RESPONSE TO REQUEST FOR ADDITIONAL INFORMATION

APR1400 Design Certification

RAI No.: 474-8588

SRP Section: 09.01.04-LIGHT LOAD HANDLING SYSTEM (RELATED TO REFUELING)

< Figure 1 Layout of Refueling Pool >

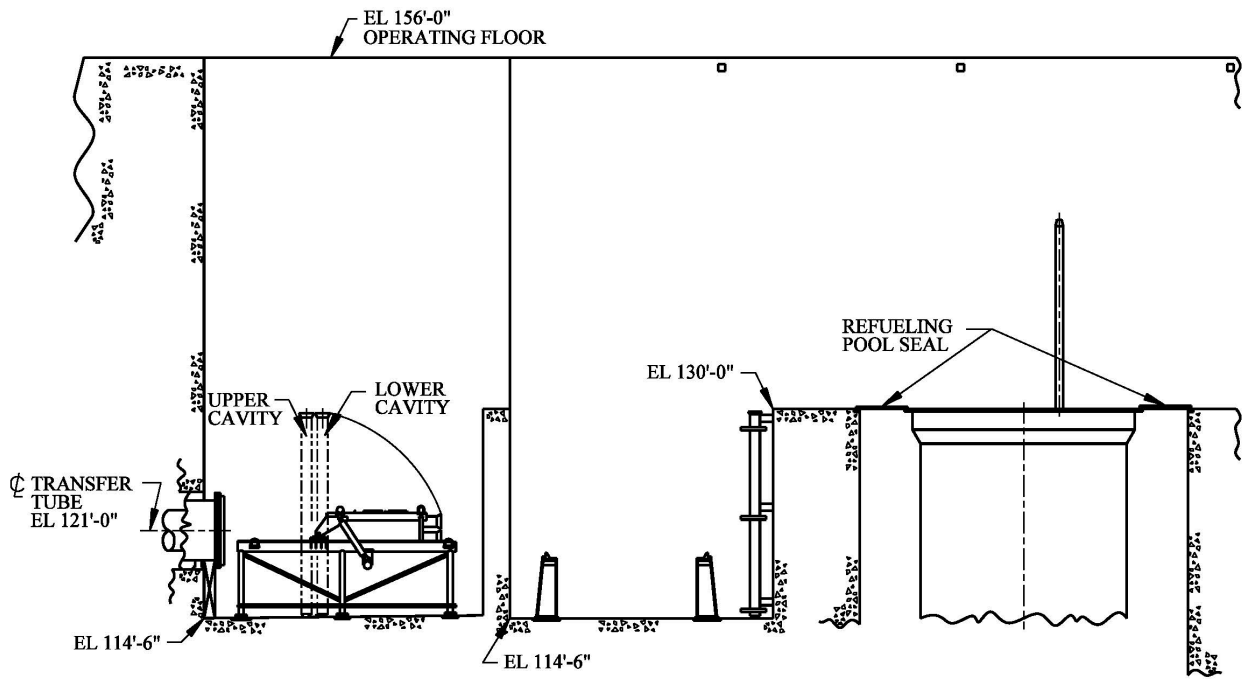
In RAI 161-7992 question 9.1.4-1 Item b, the staff requested the applicant to provide a refueling cavity drain-down evaluation, as described in SRP 9.1.4.III.3.D.ii. In its response the applicant discusses the refueling pool seal design and system misalignment.

The staff evaluated the applicant's response and determined that it does not address the drainage caused by failures of non-Seismic Category I SSCs that connect to the refueling pool.

The staff requests the applicant to identify all non-Seismic Category I SSCs that connect to the refueling pool (including their associated elevations), and to evaluate the drain-down scenario caused by failure of these non-Seismic Category I SSCs.

1. The non-Seismic Category I SSCs that connected to the refueling pool and the evaluation for the drain-down scenario are as follows :
 - a. Fuel Transfer Tube (Seismic Category II : EL. 121'-0" - Refer to Figure 1) :

The fuel transfer tube is designed to connect the containment building refueling pool and the fuel handling area transfer canal in the auxiliary building and to remain structurally intact and leak tight under seismic conditions. The welds are non-destructively inspected to confirm that there are no weld deficiencies when the fuel transfer tube is initially installed. Additionally, no matter what the leakage may occur during a postulated failure of the fuel transfer tube, the leakage water will be contained by the transfer tube penetration sleeve. Therefore, the leakage due to the postulated accident has no direct effect on the refueling pool water level.

2. The upper cavity of two cavities is only used in the transfer of fuel assembly between the containment building and the fuel handling area in the auxiliary building during refueling despite the design that the fuel carrier for the fuel transfer system consists of two cavities in APR 1400. (Refer to Figure 1)

3. If inventory loss occurs unexpectedly in the refueling pool under the condition where a spent fuel assembly is already located in the cavity fuel carrier and another fuel assembly in transit, elevated at the maximum lift elevation, the fuel assembly in the refueling pool could be immediately returned to its location in the reactor vessel or placed in another one of two fuel carrier cavity in the refueling canal. At this time, the top of the fuel assembly is completely covered by water because the refueling canal in the containment building is separated from the refueling pool by the concrete structure (Refer to Figure 1).
